STAFF REPORT

FROM: Lesley-Ann Staats, Director of Planning **FILE NO:** 3220-Eaglecrest-464
Odete Pinho, Planning Consultant ZA-2017-01

SUBJECT: Revised Zoning Amendment (ZA-2017-01, DP-2017-09) design for 464 Eaglecrest Drive (Eagle View Heights)

Figure 2: Cross section of site from revised (December 2017) application

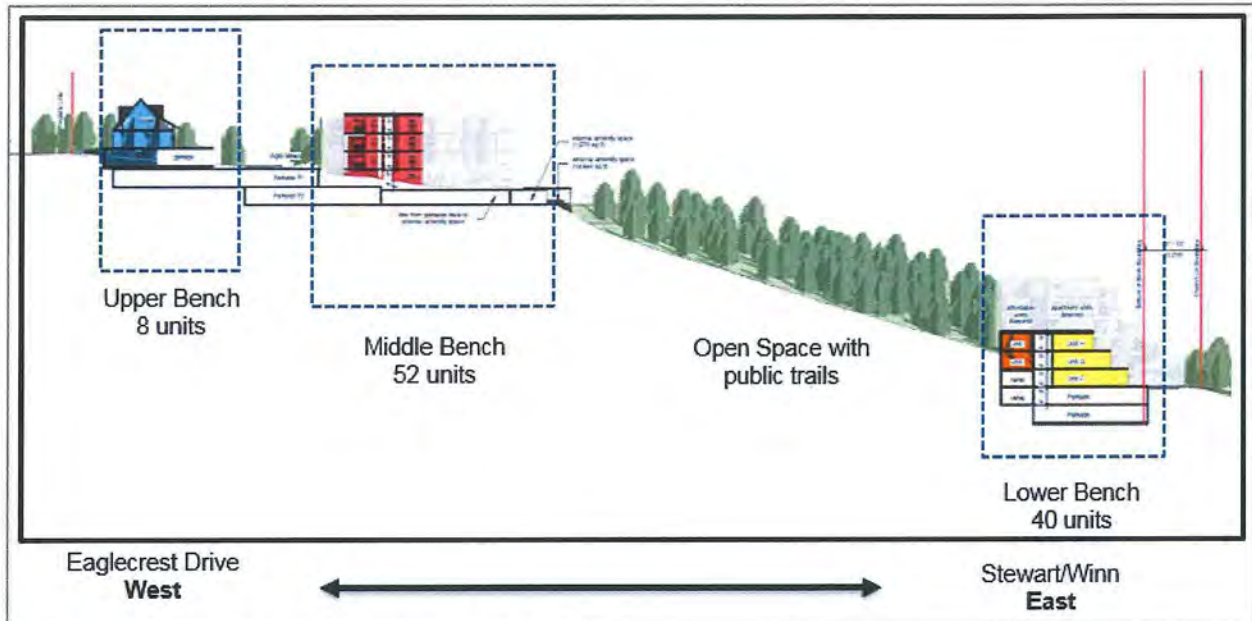
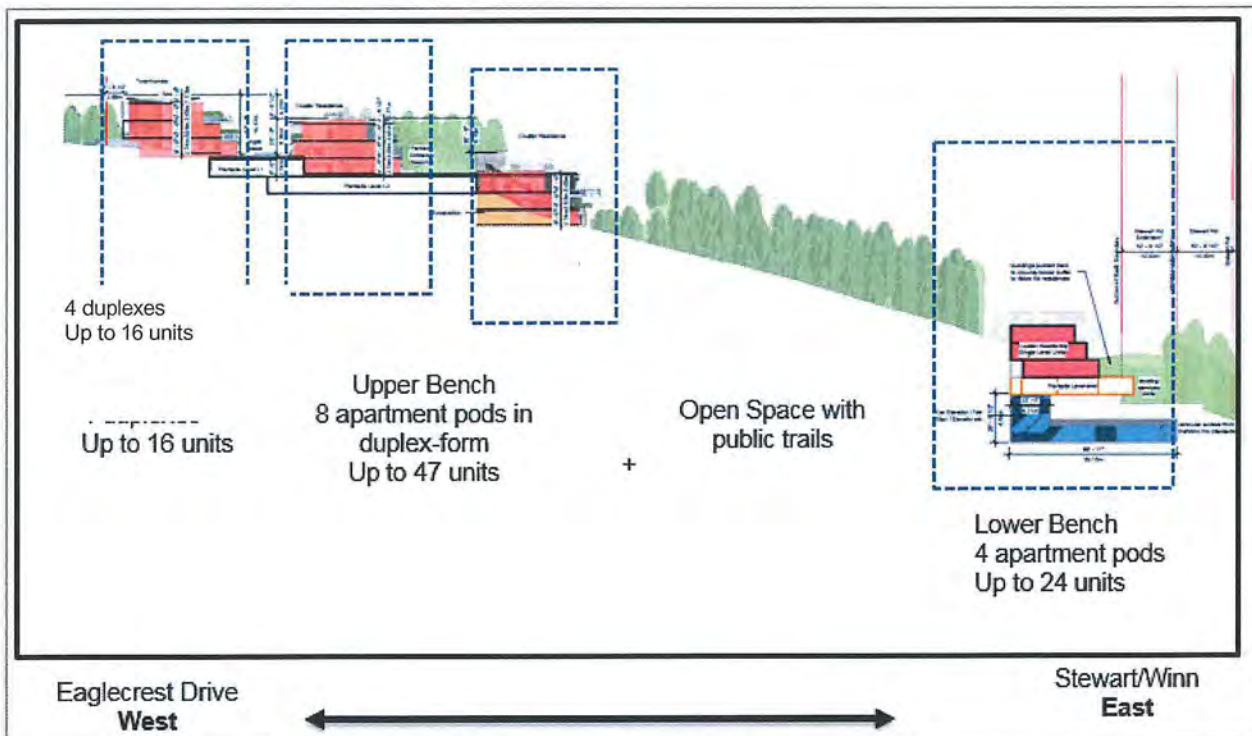
The proposal shown to Council in July 2017 (Figure 1) has been revised with buildings that are reduced in scale, height and in duplex-form (Figure 2).

Figure 5: Revised design for townhomes facing Eaglecrest Drive.

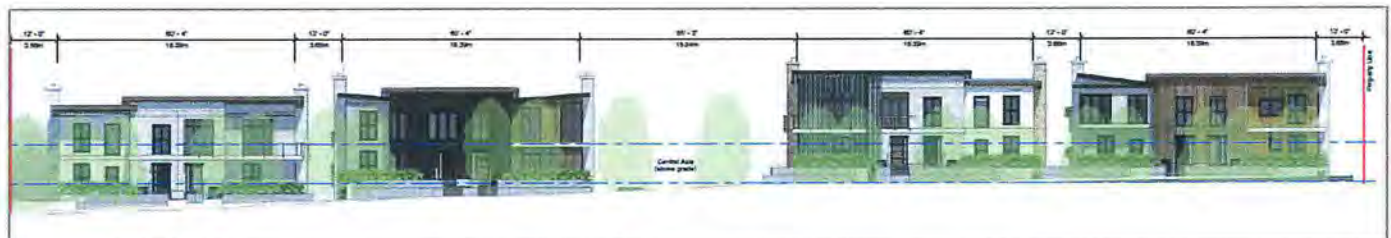
The revised plans have been adjusted to diversify the exterior materials used, separate larger apartment buildings into smaller duplex-form building pods, and reduce the overall massing appearance of dwellings through the mixing of materials and colours. The designs for the duplexes fronting Eaglecrest Drive show diverse materials and building articulation that reduces the appearance of building massing to more closely resemble single-family residential homes. The proposed materials include stone walls, hardi plank walls, and concrete planters.

Staff suggests that the revised design better fits with the neighbouring single-family residential context.

Figure 12: shows a render of the northern portion of the townhouses and condominiums on the upper bench

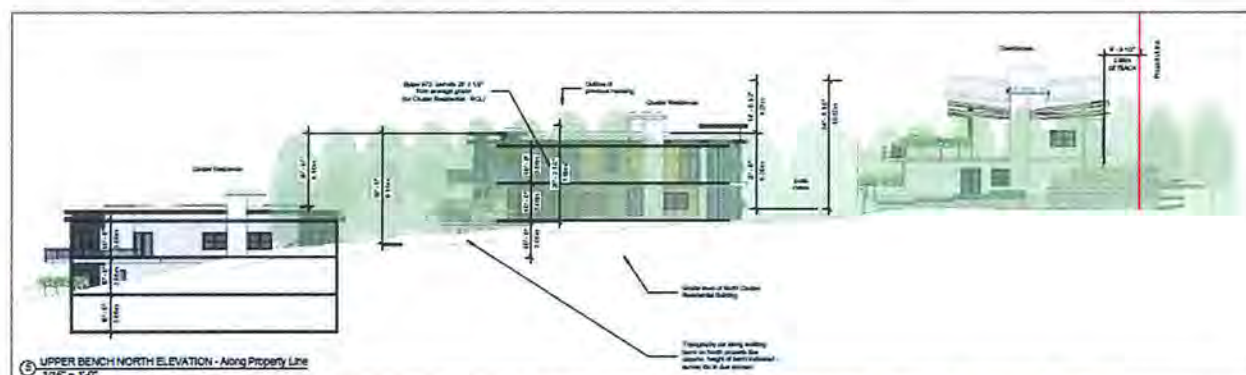
Figure 12 shows that from the northern portion of the property, the scale of the buildings has reduced significantly from the previously proposed design (initially 5 stories, now 3 stories on eastern hill slope).

Figure 13: Cross-section of the upper bench duplexes and apartments with two levels of underground parking.

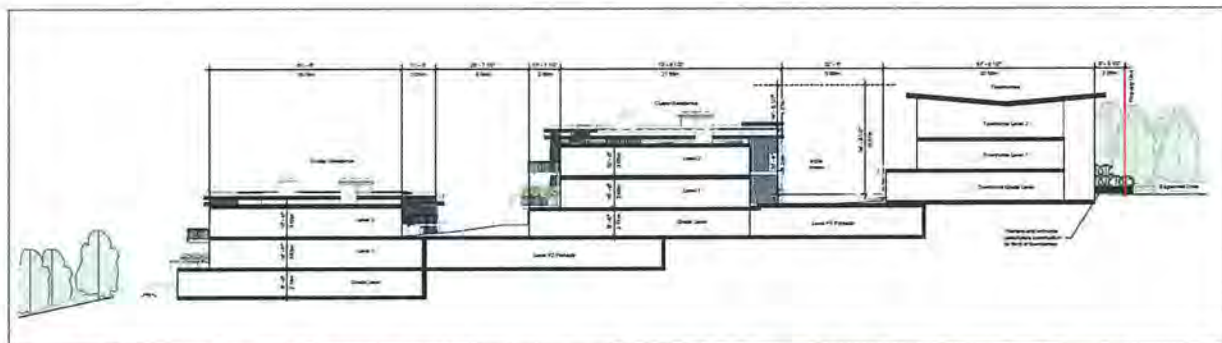
Figure 13 shows that from grade the property is 3 stories high, with 2 stories of parking underground.

Figure 14: proposed lower apartment vehicular access from Stewart/Winn Road

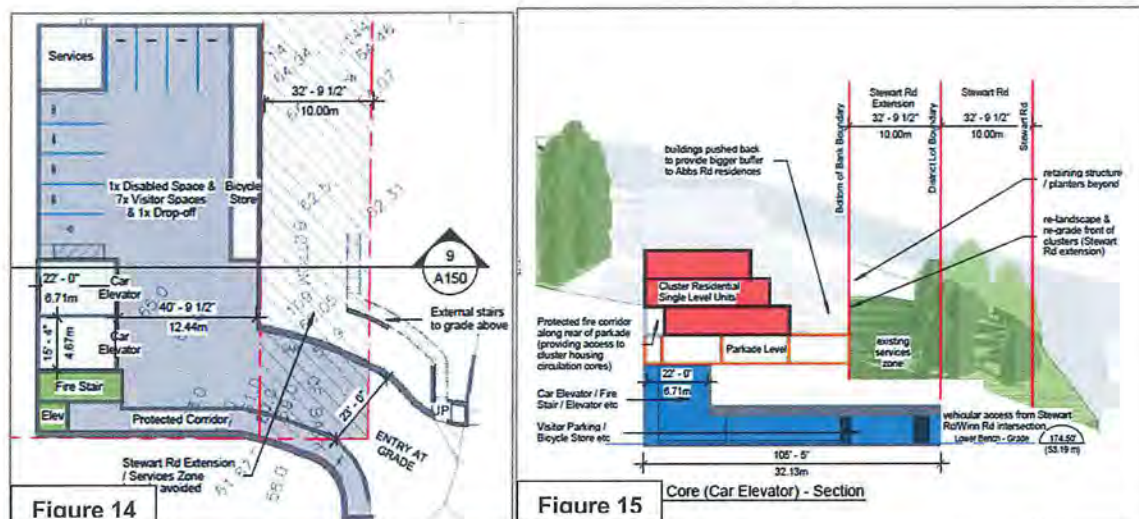
Figures 14 and 15 show close up elements of the proposed lower apartment vehicular access from Stewart/Winn Road. The slope at this section of the property grades in two directions, with the southeast corner of the lot at the lowest elevation. The gradient rises from the south to the

north and therefore the Architects have developed a design which proposes a car entrance and car elevator to access the underground parkade.
